Project	<b>IEEE 802.16 Broadband Wireless Access Working Group</b> < <a href="http://ieee802.org/16">http://ieee802.org/16</a> >	
Title	<b>MBS MAP Issue</b>	
Date Submitted	<b>2005-05-01</b>	
Source(s)	Amir Rubin, Yigal Eliaspur <b>Intel Corp.</b>	<a href="mailto:amir.rubin@intel.com">amir.rubin@intel.com</a> <a href="mailto:yigal.eliapsur@intel.com">yigal.eliapsur@intel.com</a>
Re:	IEEE P802.16e/D7	
Abstract		
Purpose	Adoption of proposed changes into P802.16e /D7	
Notice	This document has been prepared to assist IEEE 802.16. It is offered as a basis for discussion and is not binding on the contributing individual(s) or organization(s). The material in this document is subject to change in form and content after further study. The contributor(s) reserve(s) the right to add, amend or withdraw material contained herein.	
Release	The contributor grants a free, irrevocable license to the IEEE to incorporate material contained in this contribution, and any modifications thereof, in the creation of an IEEE Standards publication; to copyright in the IEEE's name any IEEE Standards publication even though it may include portions of this contribution; and at the IEEE's sole discretion to pe

Figure 1

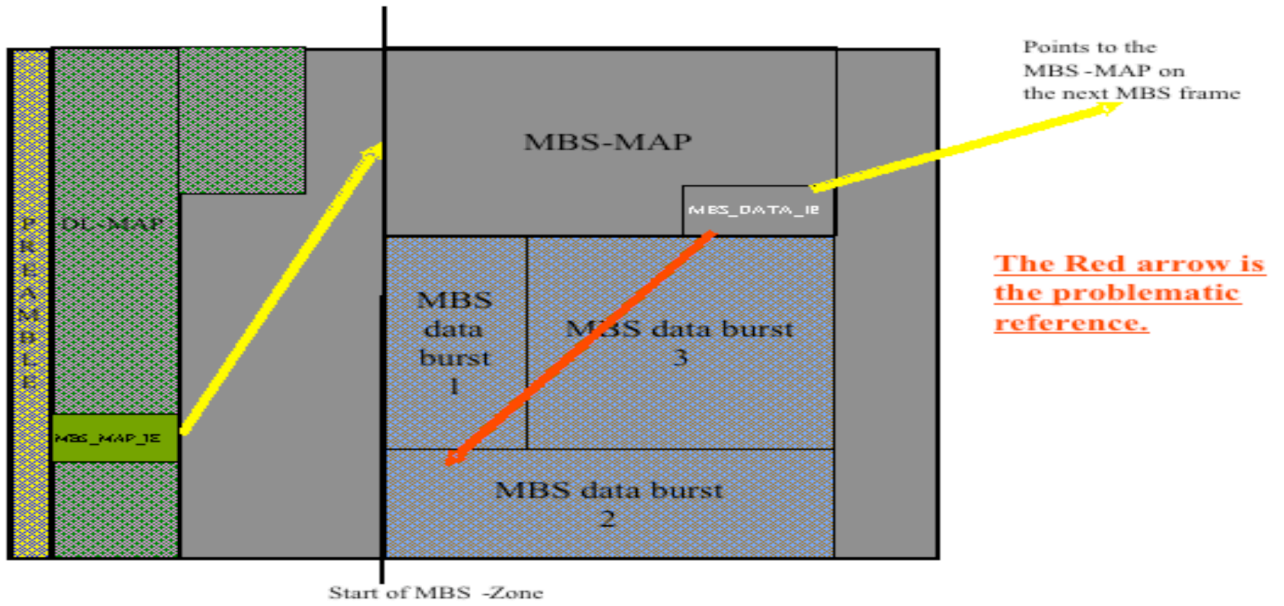
1.1 In Multi BS MBS feature the MBS-MAP relevance is currently to data bursts in the current frame. This adds significant real-time and memory requirements to the subscriber. Figure 1 demonstrates the issue.

Figure 2

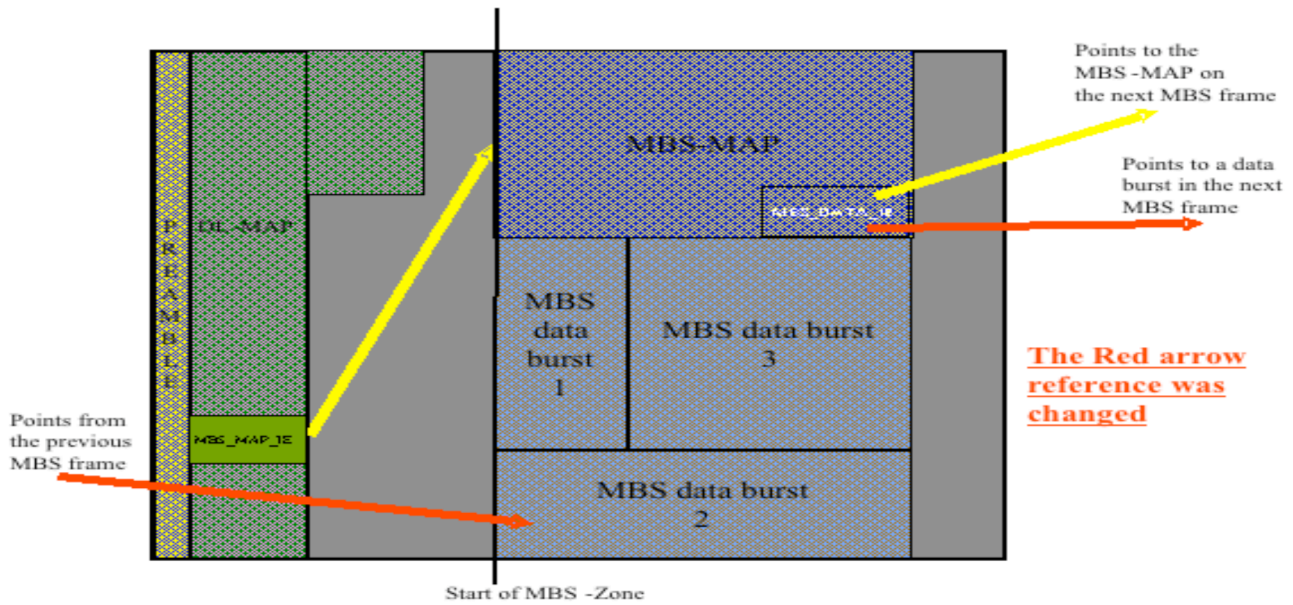
2.1 This contribution is aimed to decrease the requirements by changing the MBS-MAP relevance to the next appearance of MBS burst with the CIDs appearing in it. Figure 2 shows the proposed solution
